Attachment A  
Section 92 Response,  
parts 1, 2, 3

25 January 2024

**Te Tupu Ngātahi**  
Supporting Growth  
PO Box 105218  
Auckland 1143

## Attachment A: Section 92 response

Table 1: Proposed Flood Hazard Condition – changes since lodgement and rationale

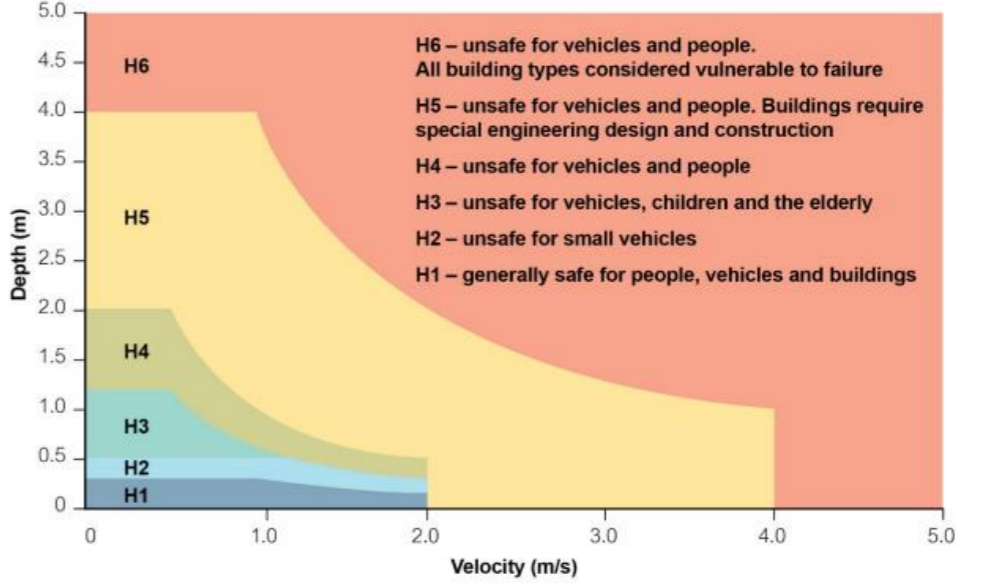
The table below sets out the Flood Hazard condition proposed at lodgment, the changes proposed as a result of a review of the condition carried out in December 2023 and our reasons for those changes.

Condition as lodged Sept 2023 (Appendix B, condition 10)	Proposed change to condition	Rationale for change from conditions as lodged
(a) The Project shall be designed to achieve the following flood risk outcomes:	The Project shall be designed to achieve the following flood risk outcomes:	N/A
<ul style="list-style-type: none"> <li>i. no increase in flood levels in a 1% AEP event for existing authorised habitable floors that are already subject to flooding or have a freeboard less than 150mm;</li> </ul>	<ul style="list-style-type: none"> <li>no increase in flood levels in a 1% AEP event for existing authorised habitable floors that are already subject to flooding or have a freeboard less than <del>150mm</del>500mm;</li> </ul>	<p>A site assessment was carried out to estimate the amount of freeboard at buildings that might be affected by flooding close to the proposed NoR boundary (refer Section 4 and the maps in Appendix 1 of the Supplementary Flood Hazard Assessment). When the freeboard was estimated, the majority of those existing floors assessed were either flooded or within 150mm of flooding. Changing to 500mm had a minor increase in the number of floors subject to this condition but the controlling criteria was typically the building with freeboard less than 150mm.</p> <p>The new criteria also provides better protection for relatively new buildings that may be constructed prior to lodgement of the OPW– which is relevant to NoRs near flooding within the Future Urban Zone.</p> <p>Increasing freeboard to 500mm for these types of buildings aligns with freeboard standards in the AC Stormwater Code of Practice for new builds.</p> <p>It is not intended to protect all future buildings – those constructed after the OPW are lodged are expected to set appropriate freeboard above the Post project flood level.</p>

<ul style="list-style-type: none"> <li>ii. no more than a 10% reduction in freeboard in a 1% AEP event for existing authorised habitable floors with a freeboard over 150mm;</li> </ul>	<ul style="list-style-type: none"> <li><del>no more than a 10% reduction in freeboard in a 1% AEP event for existing authorised habitable floors to maintain a minimum with a freeboard of over 150mm;</del></li> </ul>	<p>A percentage freeboard reduction is not needed if a freeboard of 500mm is utilised in criteria i.</p>

Condition as lodged Sept 2023 (Appendix B, condition 10)	Proposed change to condition	Rationale for change from conditions as lodged
<p>iii. no increase in 1% AEP flood levels for existing authorised community, commercial and industrial building floors that are already subject to flooding;</p>	<p>no increase in 1% AEP flood levels for existing authorised community, commercial, industrial and network utility building floors that are already subject to flooding or have a freeboard of less than 300mm;</p>	<p>This criterion has been introduced to address flood effects as these types of building are present in the Project area – such as east of SH1 (NoR4).</p> <p>Increasing the freeboard to 300mm for these types of buildings aligns with freeboard standards in the AC Stormwater Code of Practice for new builds.</p> <p>Given the potential town centre areas in the Future Urban Zone there is potential for more of them to be constructed prior to the lodgement of the OPW. The new criteria provides better protection for relatively new buildings.</p>
